CITY OF ALBUQUERQUE

**RE: 4600 Edith Blvd NE – SWMD Admin. Office and Vehicle Maintenance
Conceptual G&D Plan (Engineer's Stamp Missing)
Hydrology File: G15D202**

Based upon the information provided in your submittal received 1/31/2019, the Conceptual Grading and Drainage Plan cannot be approved until the following comments are addressed.

SHEET No. GR-1

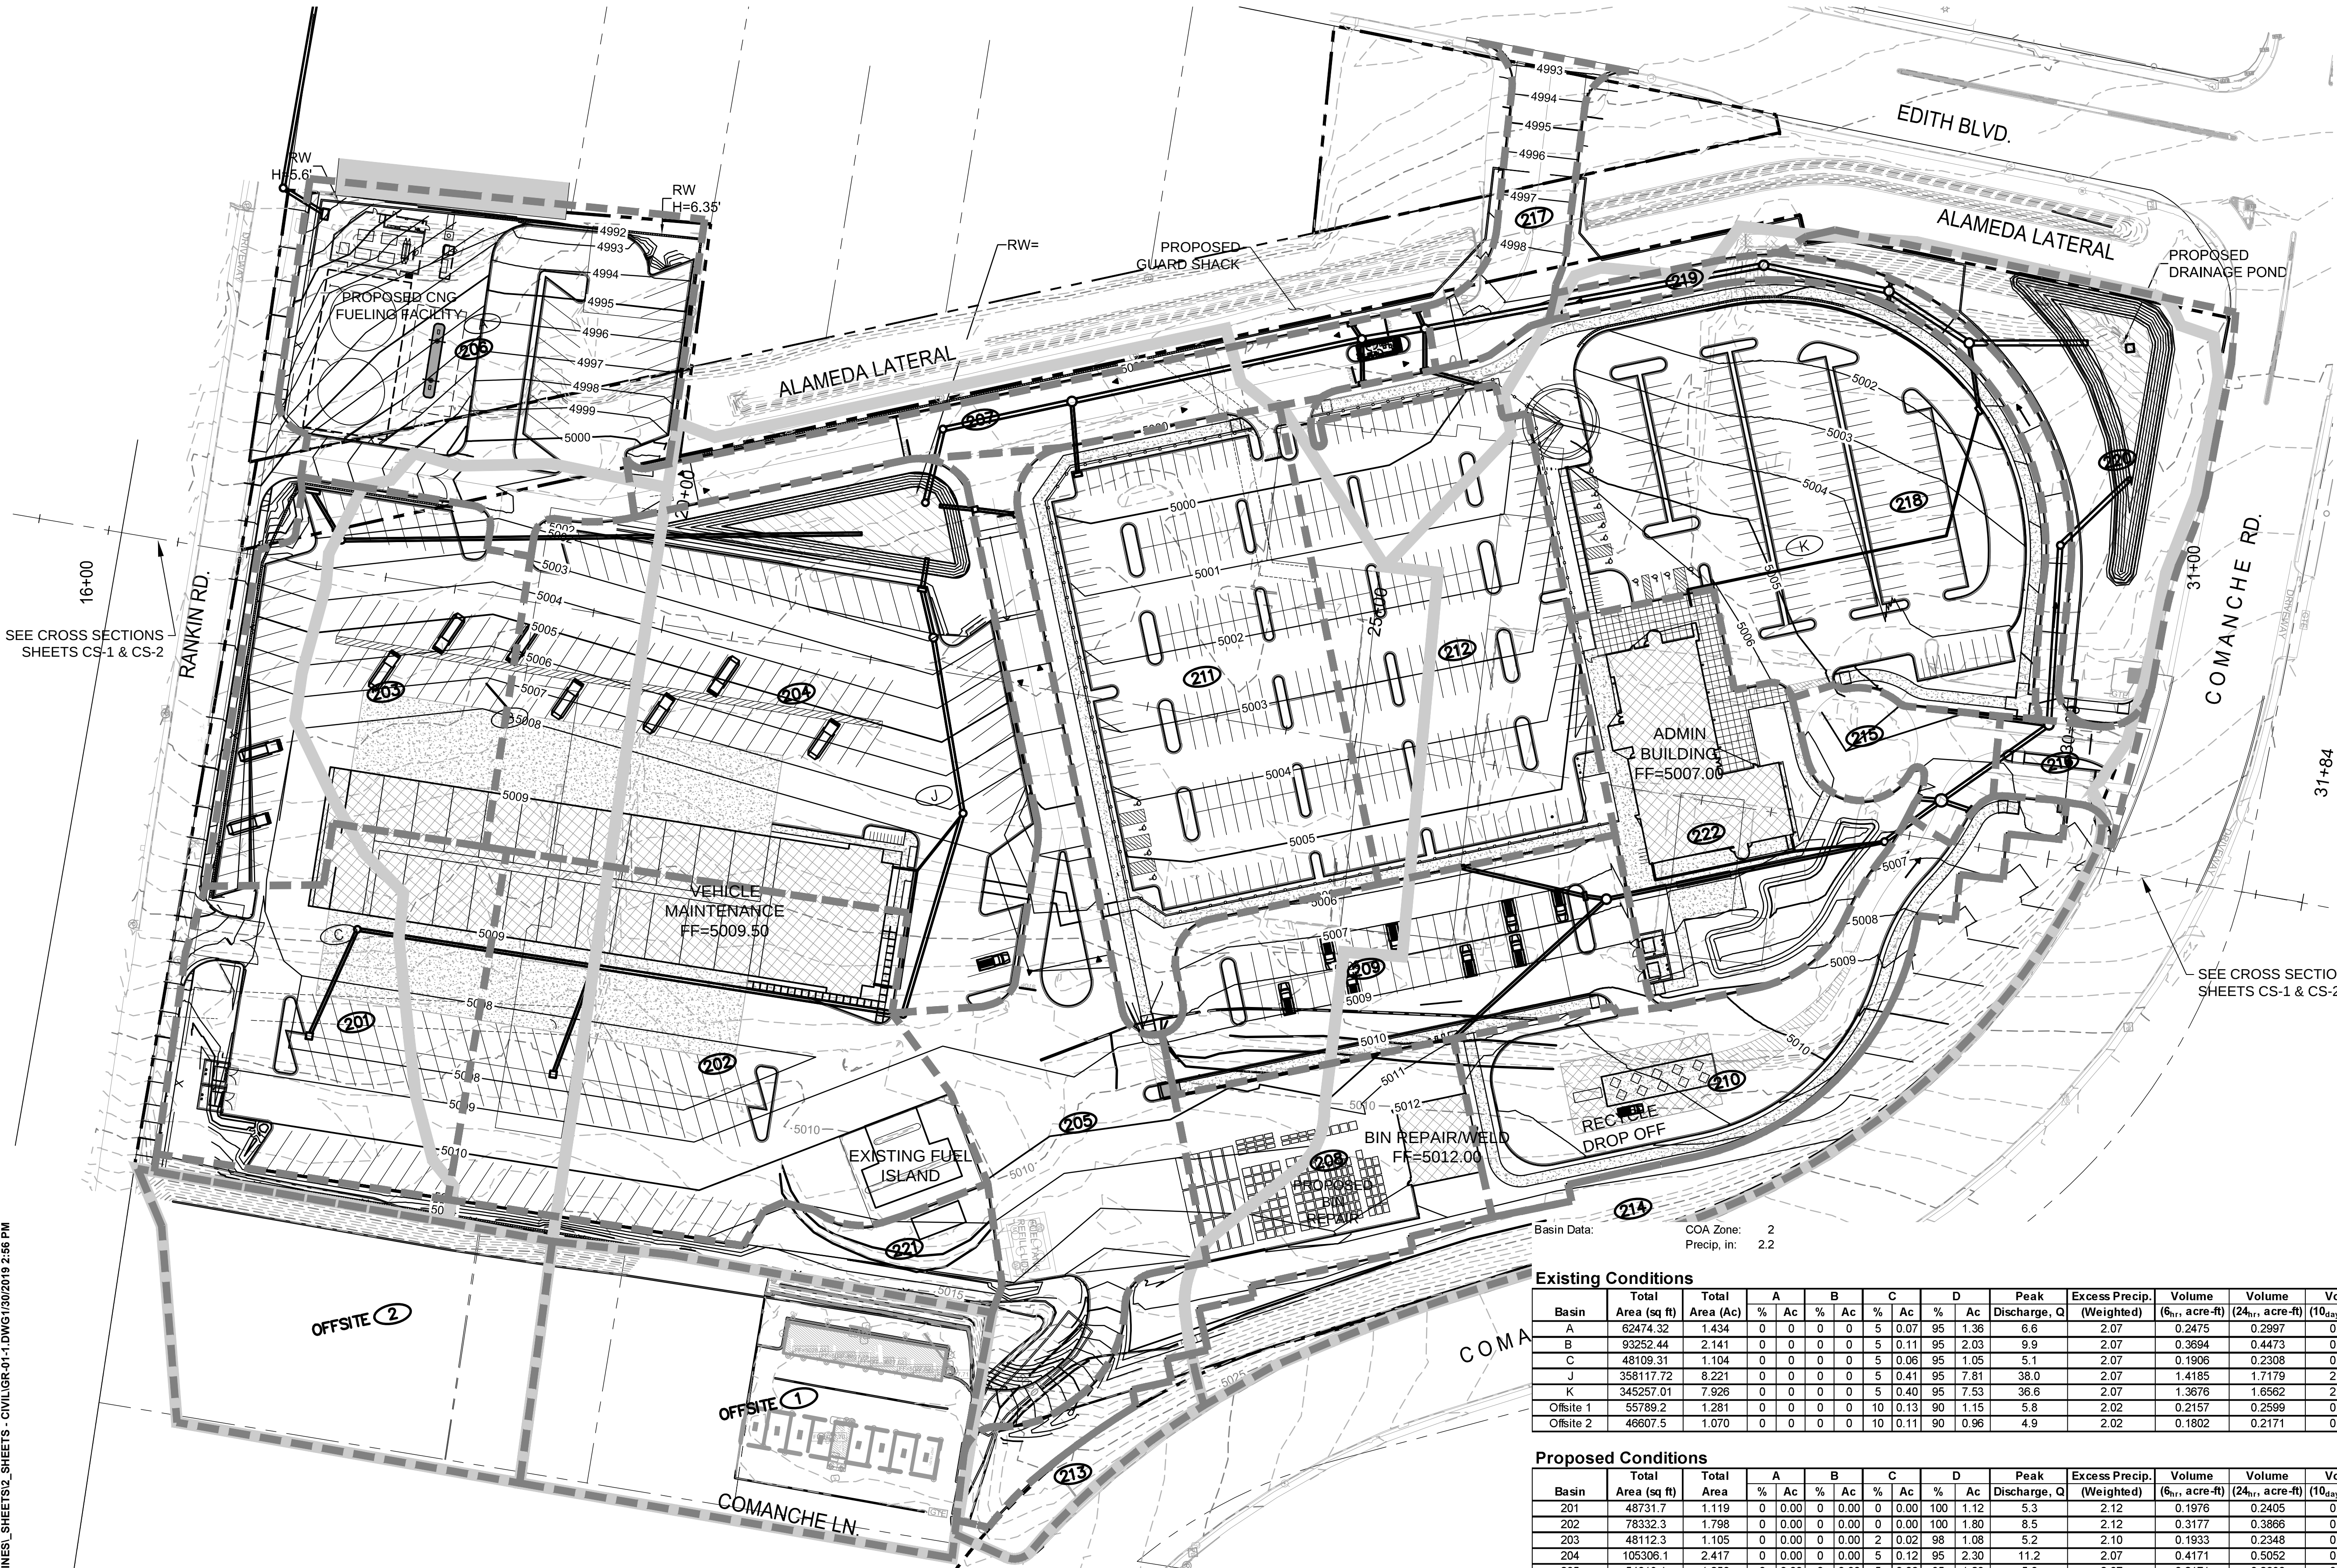
1. An Engineers stamp and date are required along with a bold label “NOT FOR CONSTRUCTION”
2. Please add a brief discussion of how the allowable discharge of 47.6 cfs was determined in compliance with § 14-5-2-12-E.
3. Please add a note describing how the SWPPP for the Multi-Sector General Permit, Sector P, will be updated.
4. Please add a note describing how the Stormwater Quality Volume will be provided as onsite retention for the 80th percentile event in compliance with § 14-5-2-6(H).

5. Provide pond design calculations, hydrology, outlet structure hydraulics, and volume calculations using the conic method.
6. Provide hydraulic calculations for surface drainage in parking lots, inlets, and HGL calculations for the on-site storm drains. Please include profiles of storm drains and pond outlet pipes.

7. Typical sections should be shown at numerous locations around the perimeter of the site. Each section should show the property line, both the existing and proposed grades, slopes and walls with dimensions, both horizontal and vertical, as necessary to demonstrate compliance with DPM 22.5.B
8. A Phasing Plan should identify which portions of the site work are to be completed with each building.

9. An engineer's Certification will be required for each building.
